# Service Bulletin

Bulletin No.: 18-NA-056

**Subject:** Side Object Sensing Alert Module Not Working Correctly and/or Incorrect Side Mirror Notification

4974639

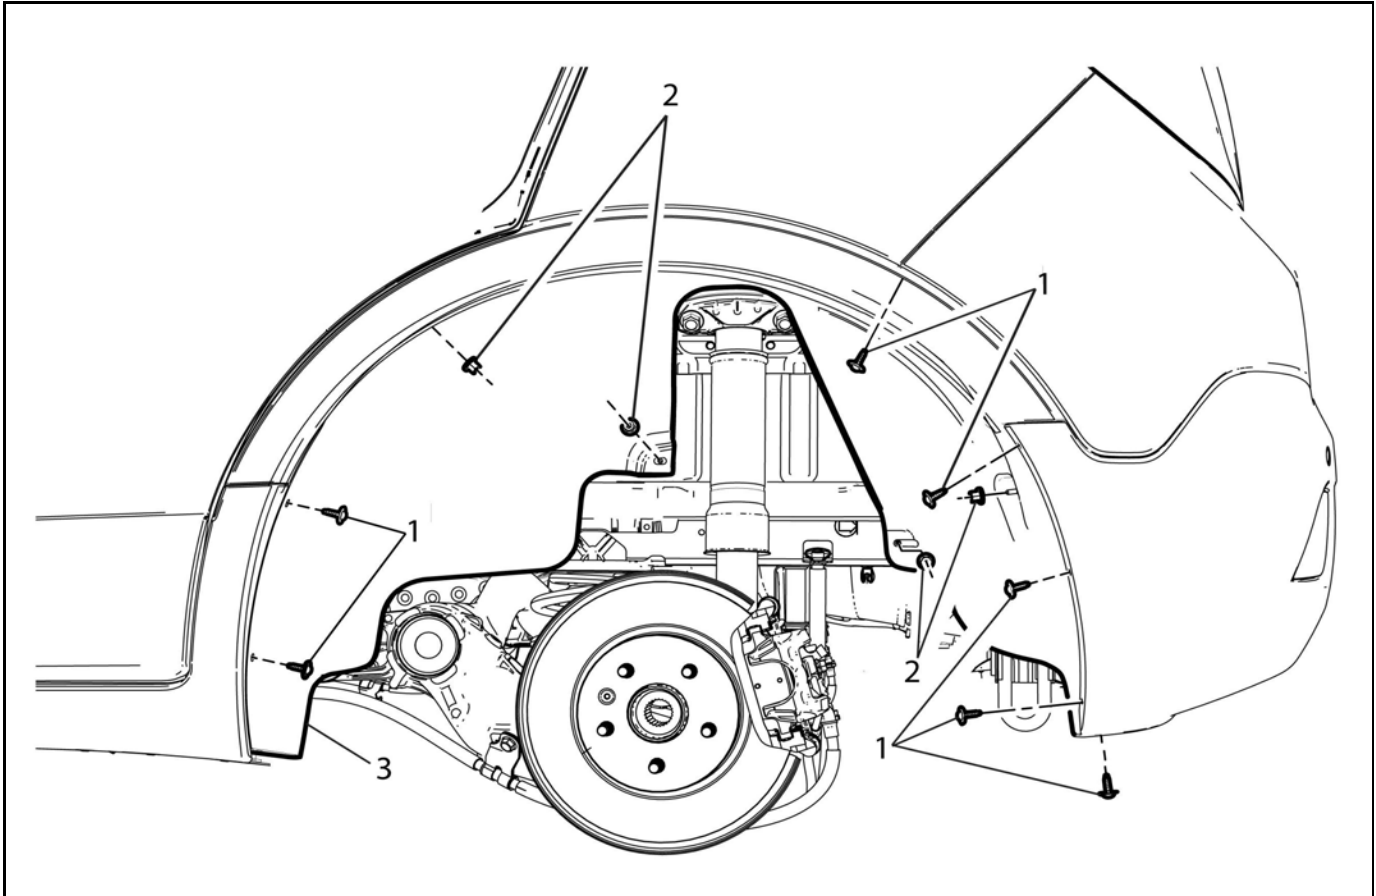
<p><b>Note:</b> Most radar reflections may be found worse on the driver side than the passenger side.</p> <p>This condition may be caused by unwanted radar reflection being detected and triggering the false alerts.</p>
<b>Correction</b>	If the side blind zone has been found not working properly, apply a piece of aluminum butyl tape to the bottom of the side object sensing alert module.

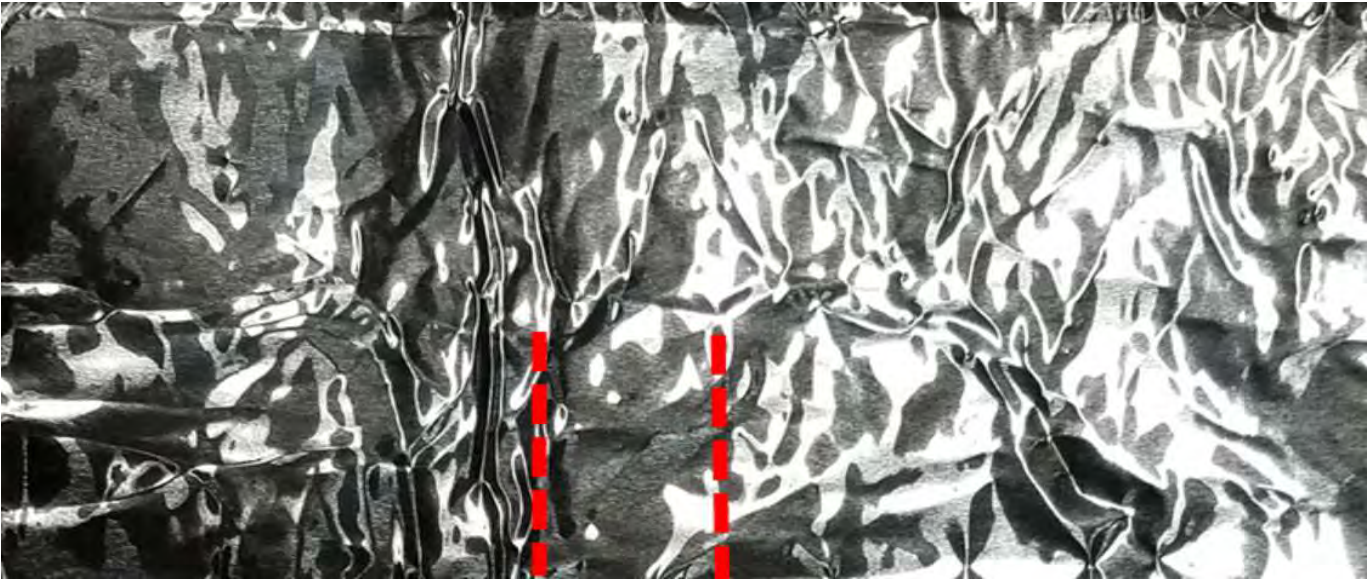
**Note:** The lower area must be completely covered, including the wire harness anchor point, to avoid unwanted radar reflections to be detected.

8. Align the pre-cut relief with the reflector mount (2).
9. Peel the backing off the aluminum butyl tape and apply to the bottom of the module (1) and fascia making sure the area is completely covered as shown in the graphic above.
10. Install the wiring harness into the anchor point (3).
11. Install the affected side wheelhouse liner.
12. Lower the vehicle.
  - If the side blind zone and/or side mirror indicators are performing properly, no further action is required.
